INSERTION INSTRUCTIONS FOR AMENDMENT 6

BVPS-2 ER-OLS

FIGURE E290.7-2
 STATION SERVICE TRANSFORMERS
 BEAVER VALLEY POWER STATION-UNIT 2
 ENVIRONMENTAL REPORT
 OPERATING LICENSE STAGE

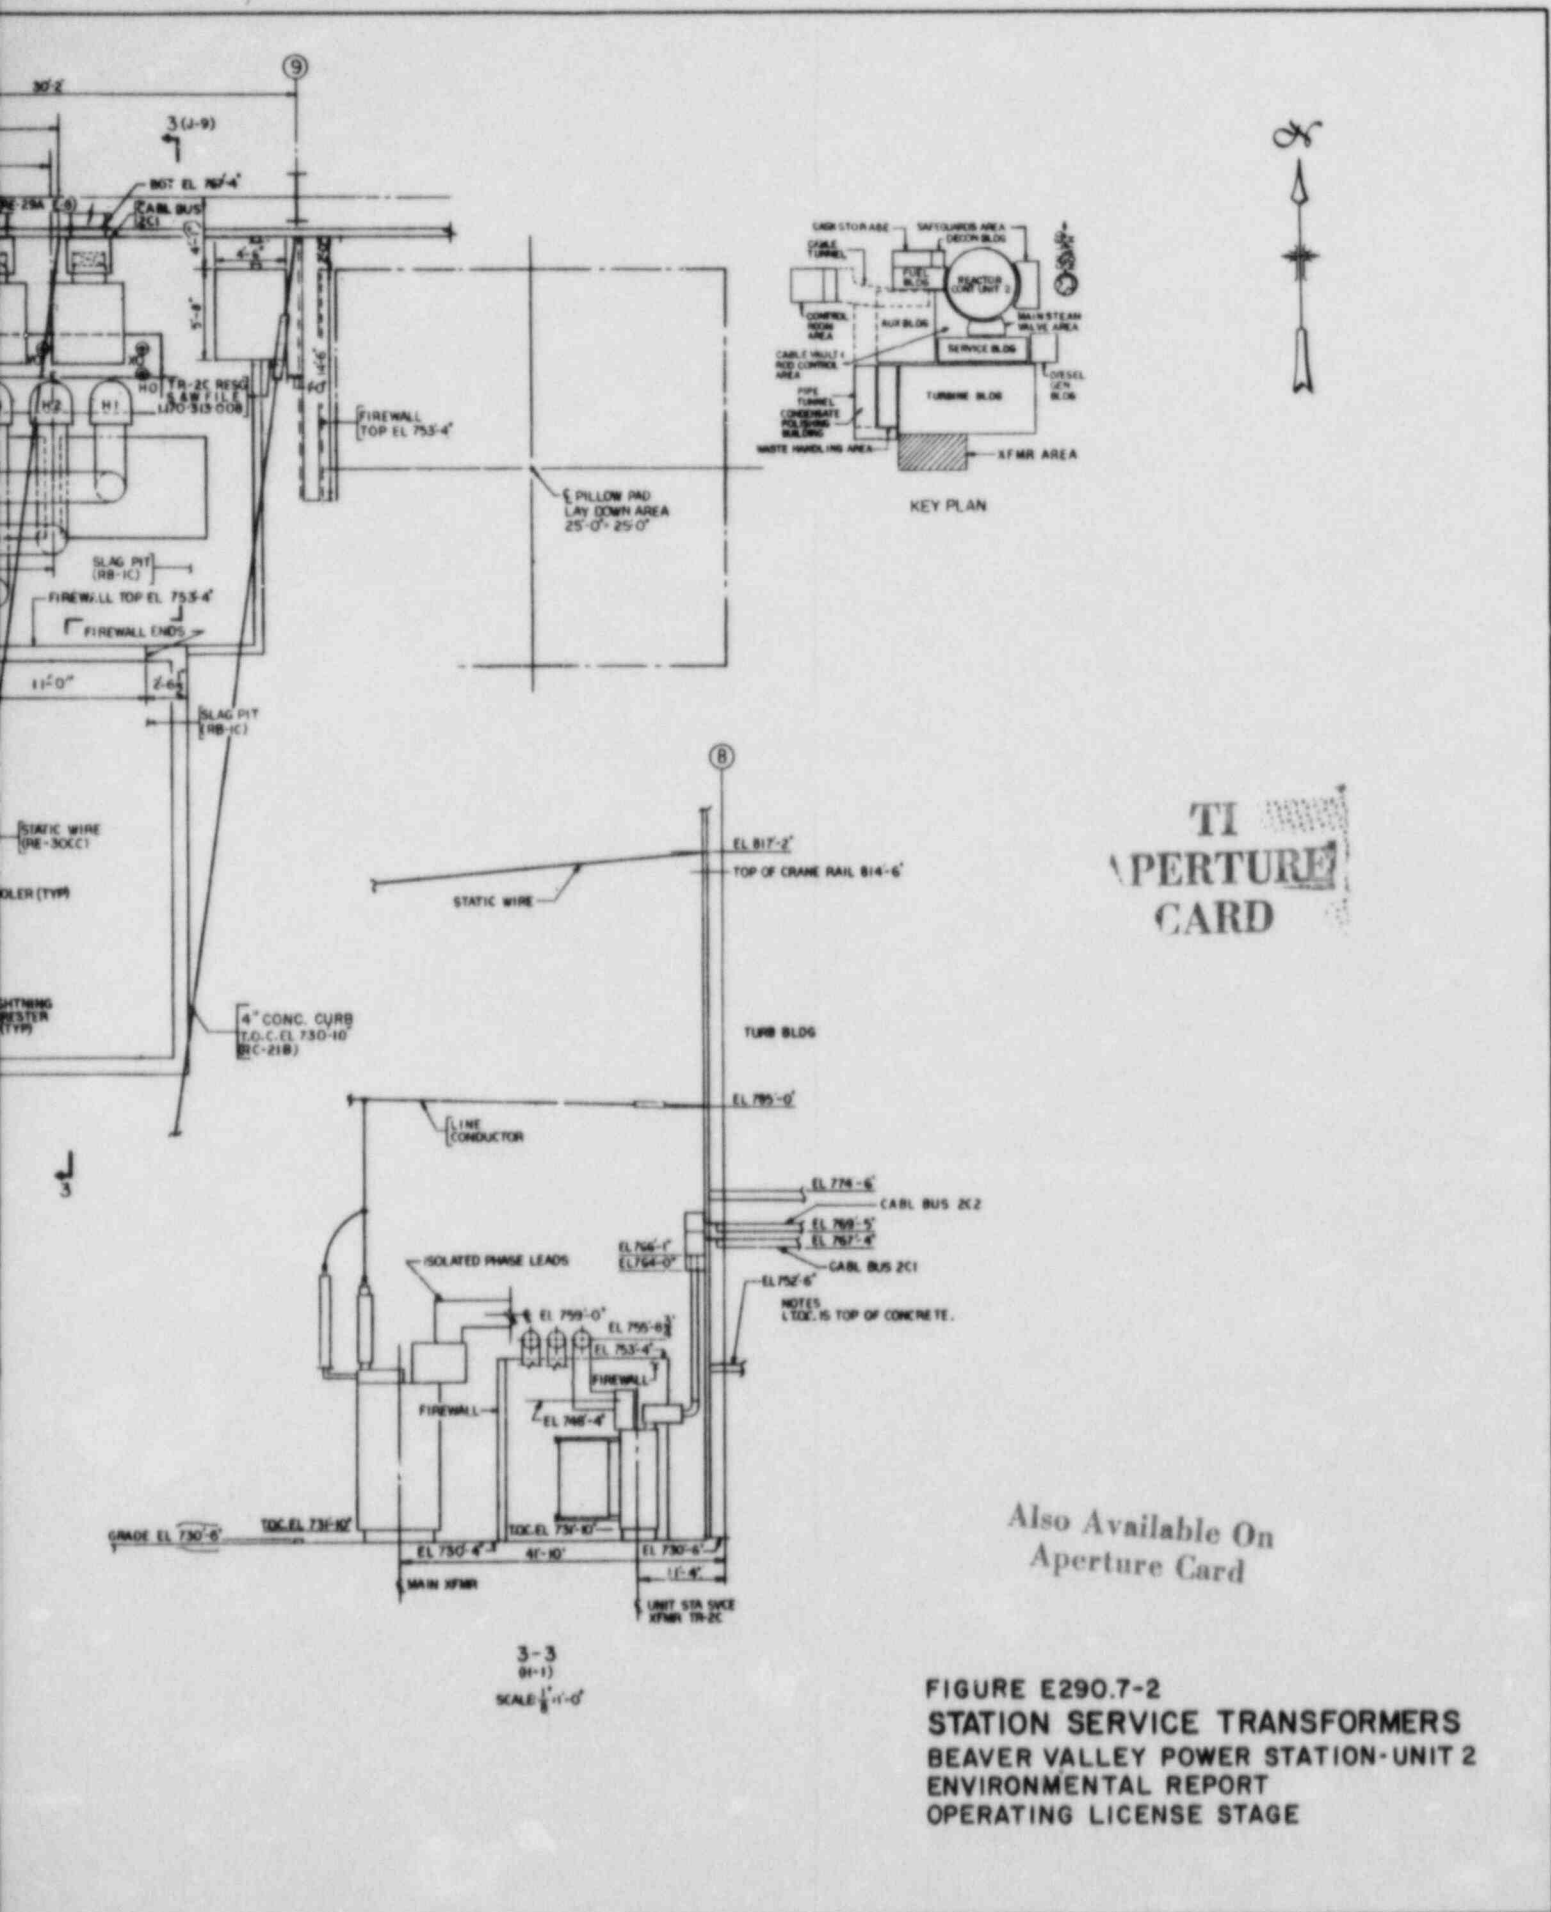
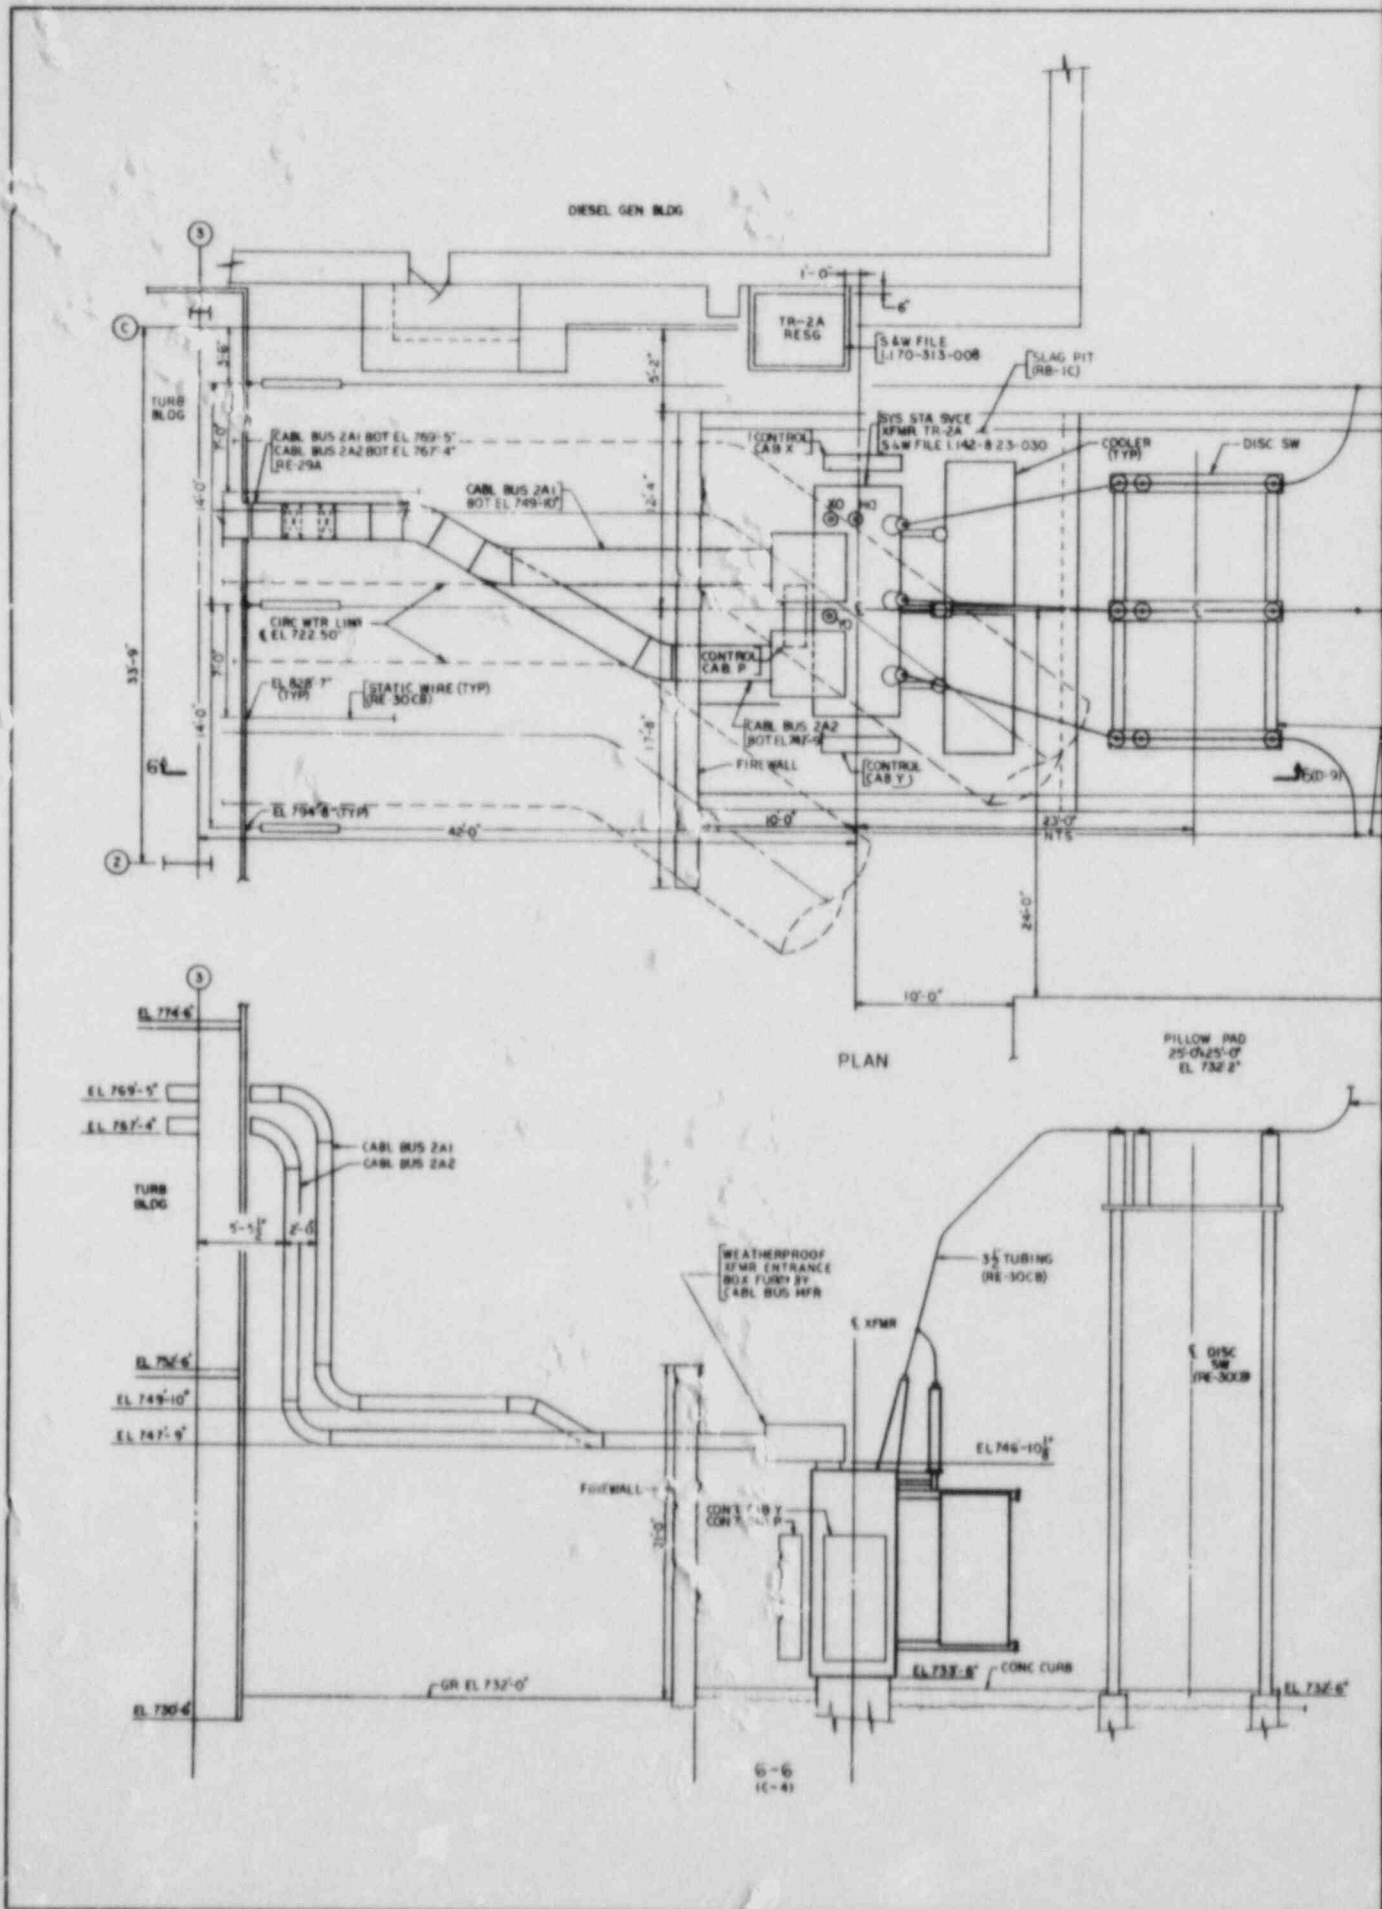
Provide a scaled plan view sketch of the location of the transformers (main and auxiliary) and their firewalls. Mark on the drawing the distances between transformers and firewalls. Note also the height of the firewalls and height of the transformers. Construction layout drawings for the region around the main and auxiliary transformers are an acceptable alternative to the sketches since the detailed drawings should provide the same information.

Figures E290.7-2, -3 and -4 show the detailed arrangements of the transformer areas, including the locations of the firewalls. The heights and locations of the firewalls can be obtained from these drawings.
